UPPER MOKELUMNE RIVER WATERSHED DEVELOPMENT AND PLANNING PROJECT

Comment #	Commenter	Commenter Organization	Page Number	Section, Figure, or Table Number	Sentence Starts with, "..."	Comment
1		EBMUD	p. 2-3	2.1.1.1	"Figure 2-2 shows the distribution..."	The text says that a large number of wells do not have construction depth or screen interval information. Were only the wells with construction information used to prepare the GW elevation contour maps for each principal aquifer?
2		EBMUD	p. 2-12	2.1.4.2	4th paragraph of Sec 2.1.4.2, 3rd sentence "Flow in the Mokelumne River below the Camanche Reservoir varies seasonally..."	Please modify the discharge values from Camanche Reservoir discussed in the third and fourth sentence of this paragraph. Releases from the Camanche Reservoir could be as low as 100 cfs during critically dry years and up to 5,000 cfs during the wet season. Since the Camanche Dam was completed in 1964, the maximum daily release from the Camanche Reservoir has not exceeded 5,000 cfs. The Mokelumne River flows recorded below Camanche Dam prior to 1964 are not representative of flows observed after the dam was built.

Figure 2-14 Potential Recharge Areas

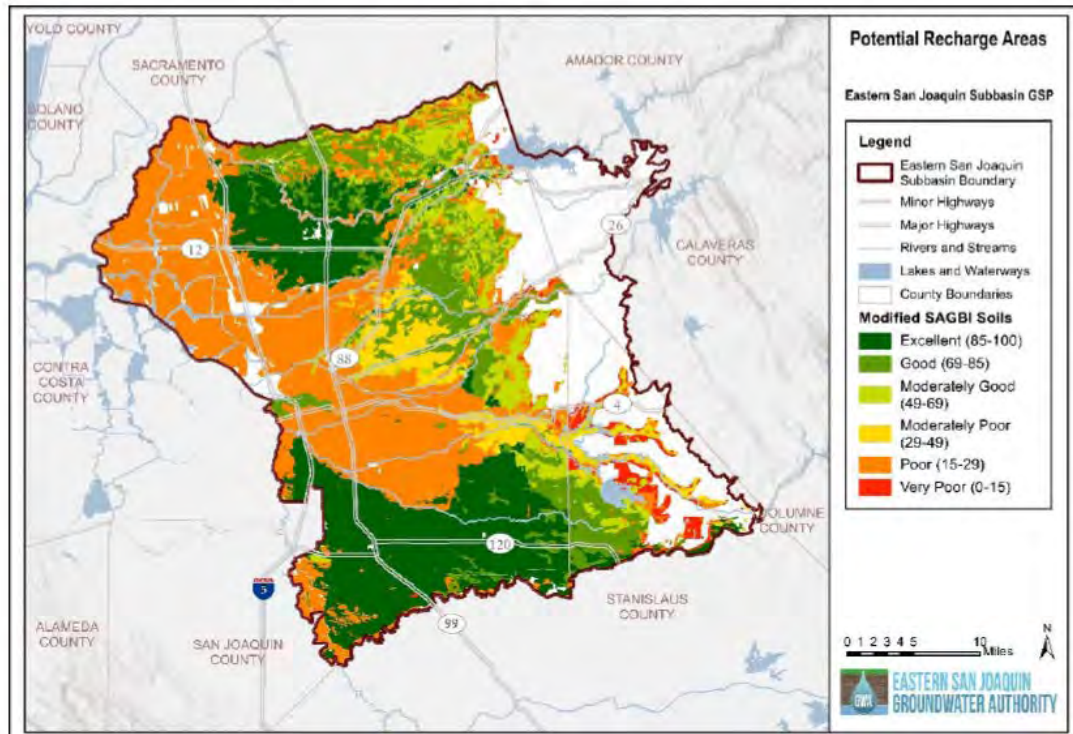
Groundwater recharge areas were not specifically addressed in GSP Section 1.2.3.4 but instead were discussed in 2.1.4.5.3: Description of Potential Recharge Areas. Modified SAGBI data was used to categorize 310,098 acres out of 610,890 acres (51 percent) of agricultural and grazing land within the Subbasin as moderately good, good, or excellent for groundwater recharge. The Modified SAGBI data show higher potential for recharge than unmodified SAGBI data because the modified data assume that the soils have been or will be ripped to a depth of 6 feet, which can break up fine grained materials at the surface to improve percolation. A generalized map was provided of potential recharge areas as shown below, but a map identifying existing recharge areas that substantially contribute to the replenishment of the groundwater basin was not found in the draft GSP.

SGMA requires that a map identifying existing and potential recharge, and specifically identifying the existing recharge areas that substantially contribute to the replenishment of the groundwater basin. This map shall be provided to the appropriate local planning agencies so that appropriate protection measures may be considered for adoption. In order to enhance recharge opportunities, land use planning that restrict paving and build over in an important mechanism. Good land use policies are necessary components to achieve the sustainability goals for the basin; so that existing recharge can continue and that development of additional regional recharge areas can become part of local water resource and community development plans.

Figure 3-2: Location of Representative Monitoring Wells for Groundwater Levels

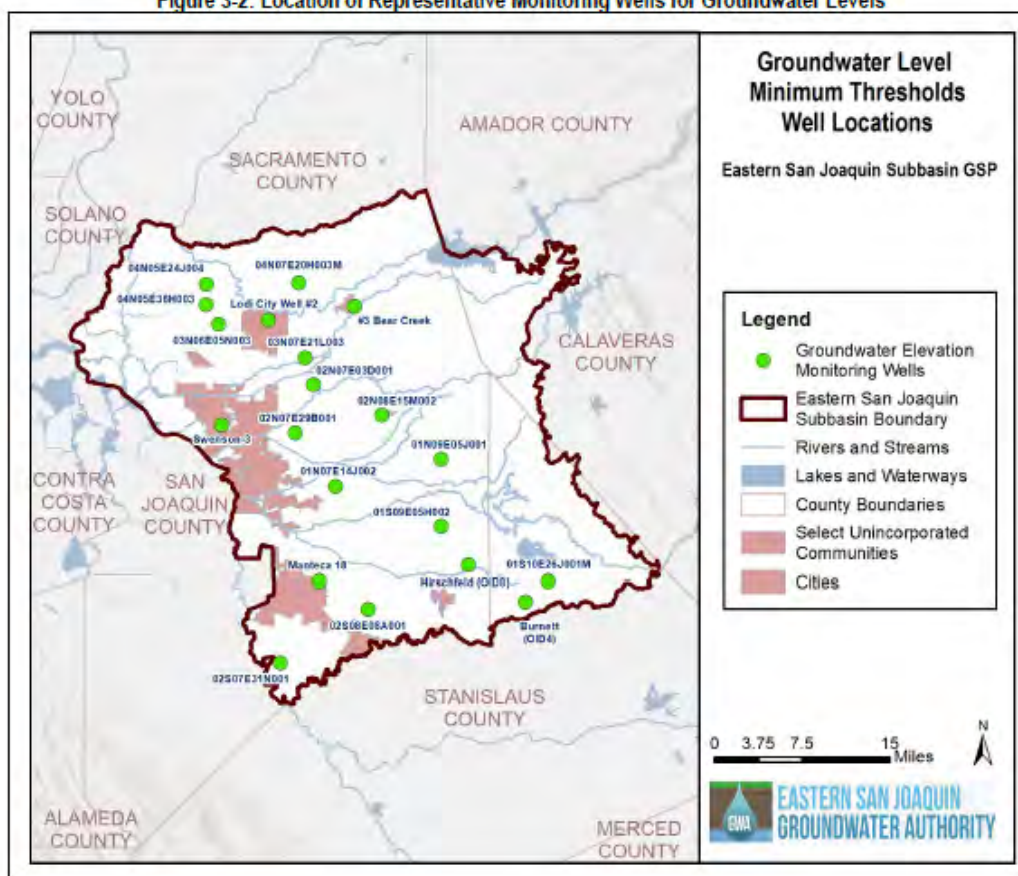
The draft GSP uses groundwater level minimum thresholds as a proxy for the depletion of interconnected surface water sustainability indicator. As such, the minimum thresholds for the interconnected surface water sustainability indicator are the same as the minimum thresholds for the chronic lowering of groundwater levels sustainability indicator. The use of the existing representative groundwater level monitoring wells is inadequate to assess whether or not surface waters are depleted by groundwater extraction wells near surface waterways. Figure 3-2 from the draft GSP shows the minimum threshold compliance well locations. Based on the scale of the legend the nearest well to a surface waterway is Bear Creek #3 which may be up to approximately 1 mile away from Bear Creek (0.5/2*3.75 miles) and operated by the Lockeford Community Services District which also operates wastewater infiltration ponds in the vicinity as shown in the snapshot from the 2007 Central Valley Regional Water Quality Control Board Waste Discharge Requirements¹⁵
